RE: Addendum to Grandfathers Gully Water Cycle management report

A review "*review*" of the Water Cycle Management Report "*report*" for the rural residential development of Lot 2 DP 250984 was commissioned by the Department of Planning (DoP) and undertaken by Whitehead and Associates.

APPENDIX A – UPDATED LAYOUT

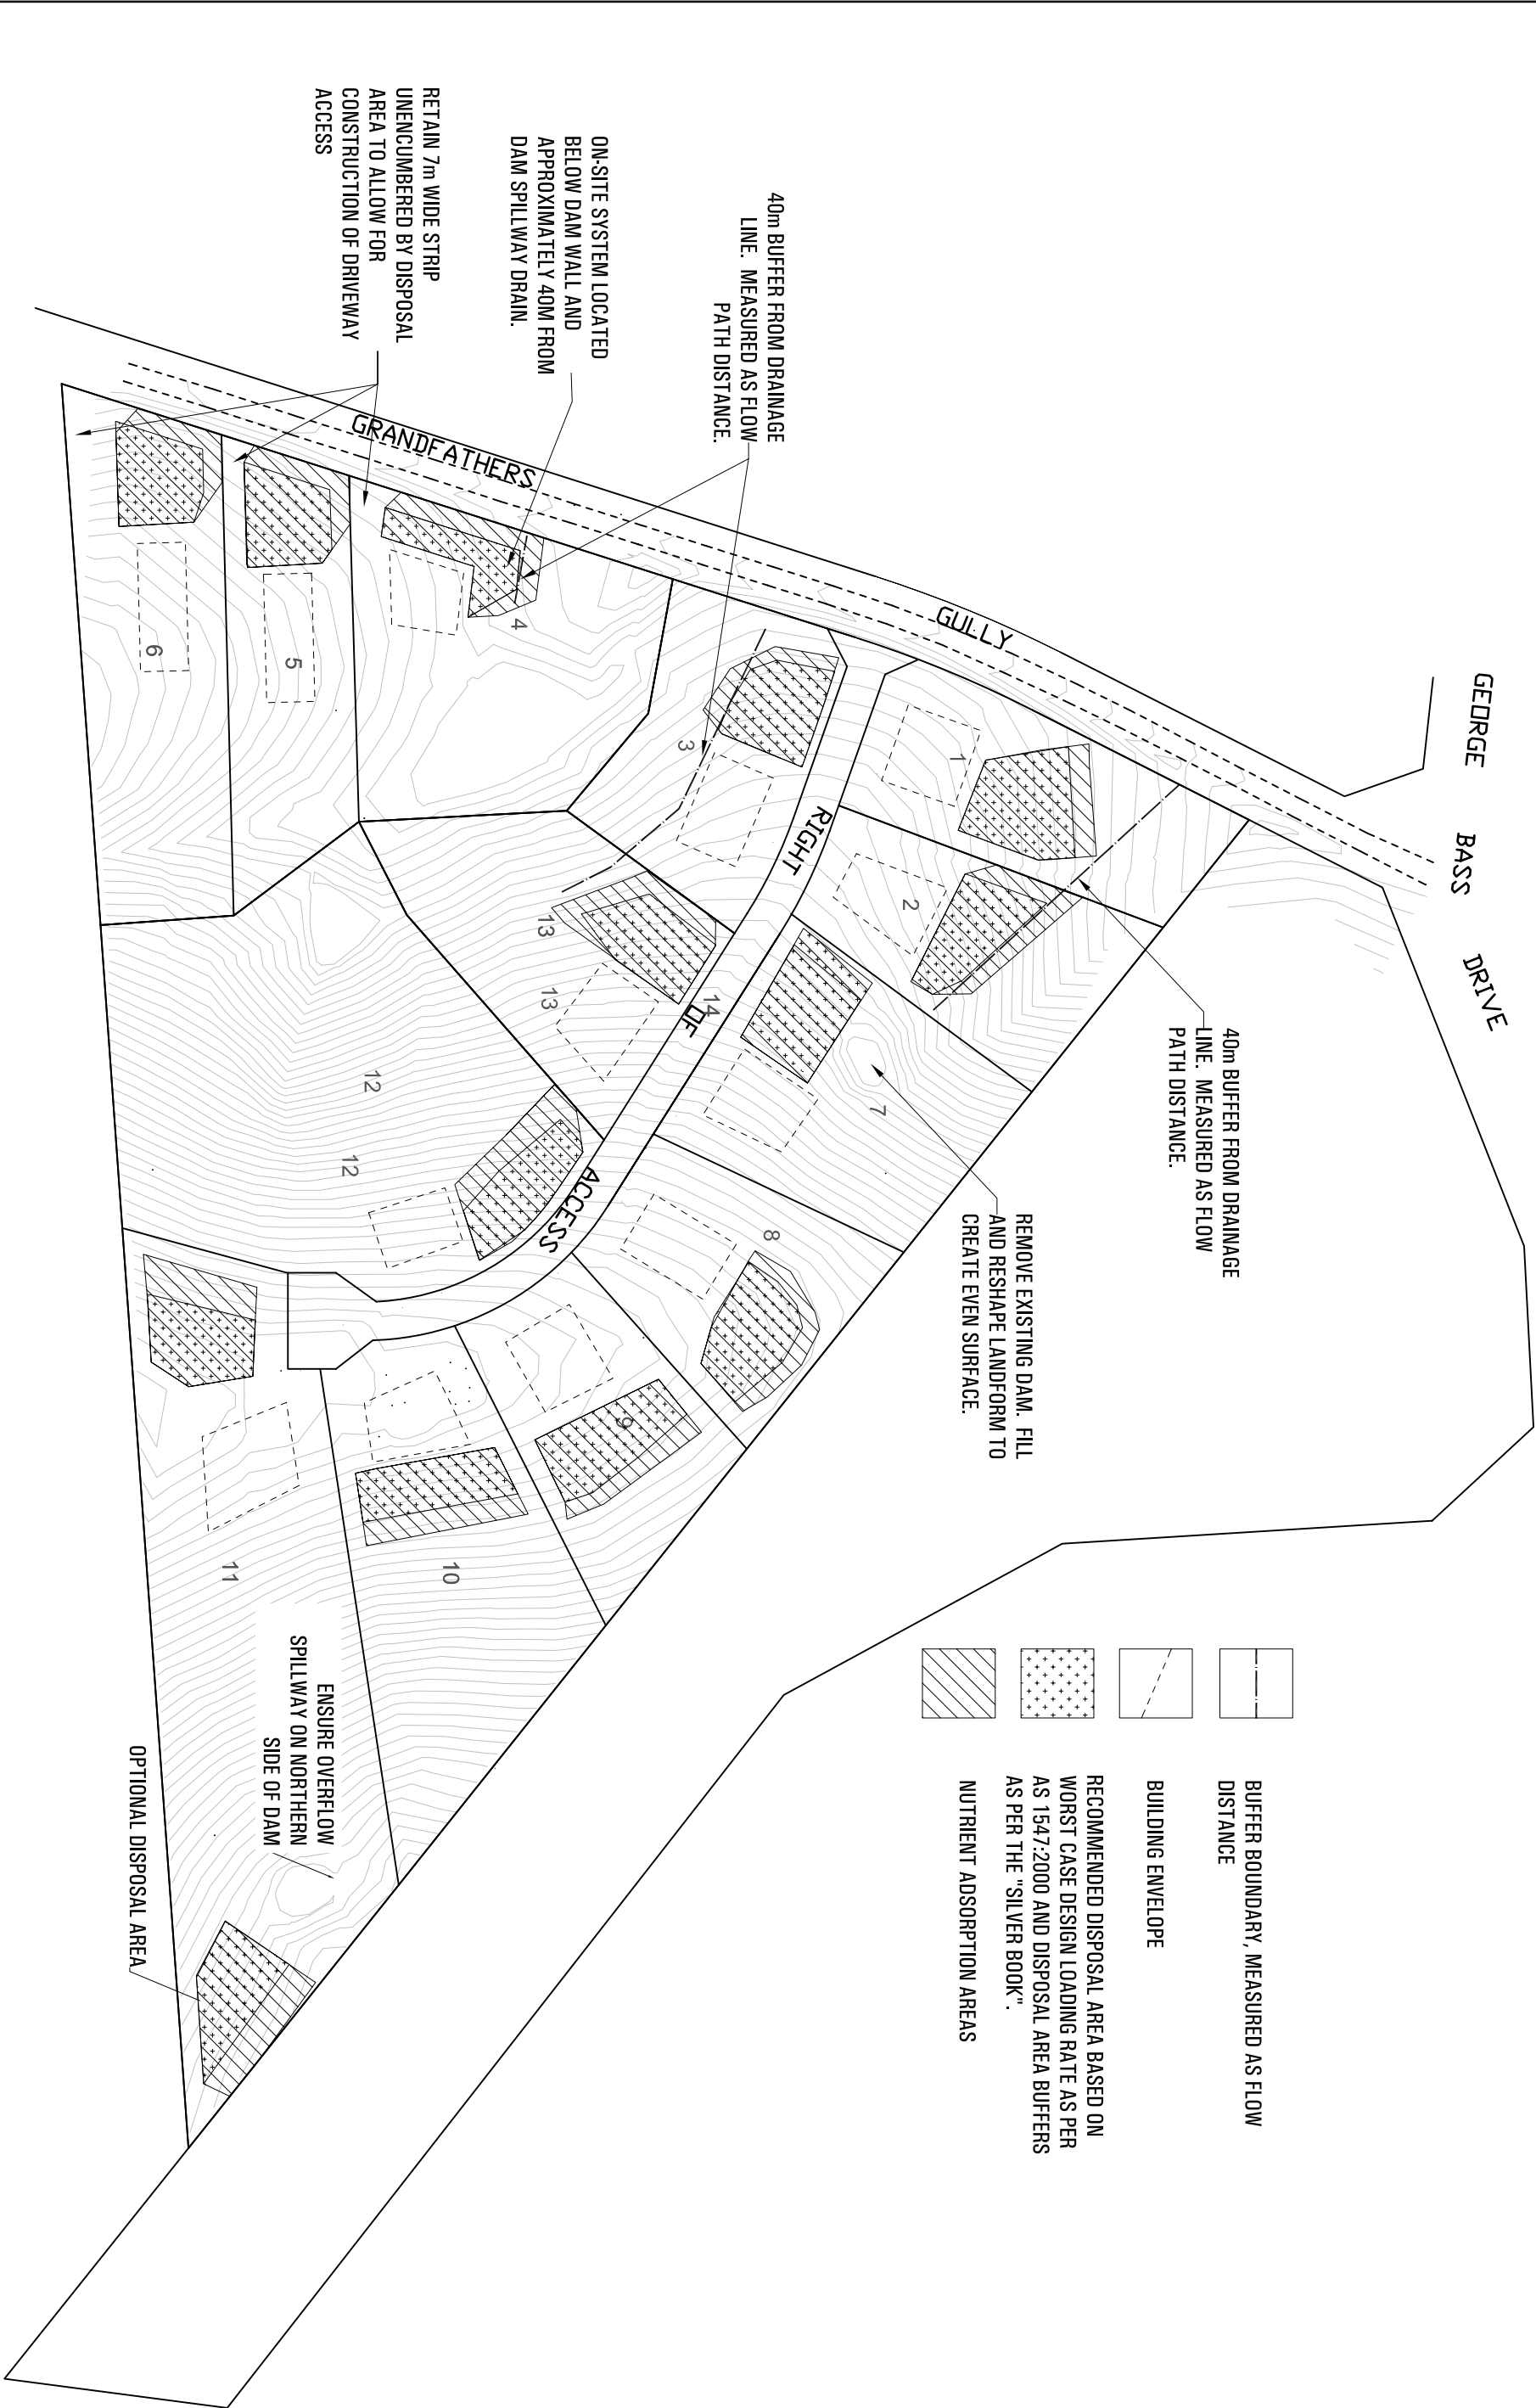
We have reviewed these issues and have updated the water balance model to incorporate updated climate information, amended the lot layout, amended the effluent loading rates and amended the disposal areas to provide a more conservative approach across the site.

An updated summary of design parameters is contained in Table 1, including specific requirements for steep sites. An updated lot layout and location of nominated disposal areas and nutrient absorption areas is contained in appendix A. Updated water balance and nutrient balance calculations that agree with the *review* are contained in appendix B.

- A minimum 719m² of sub-surface irrigation area is recommended for each lot within the area shown in appendix A, apart from lots 4, 5 and 8 which may be suitable for a mound disposal system which would require in the order of 300m².

- The *report* outlined the specific shape and size of irrigation areas. We now recommend that the configuration of disposal areas be determined during development applications for individual blocks.
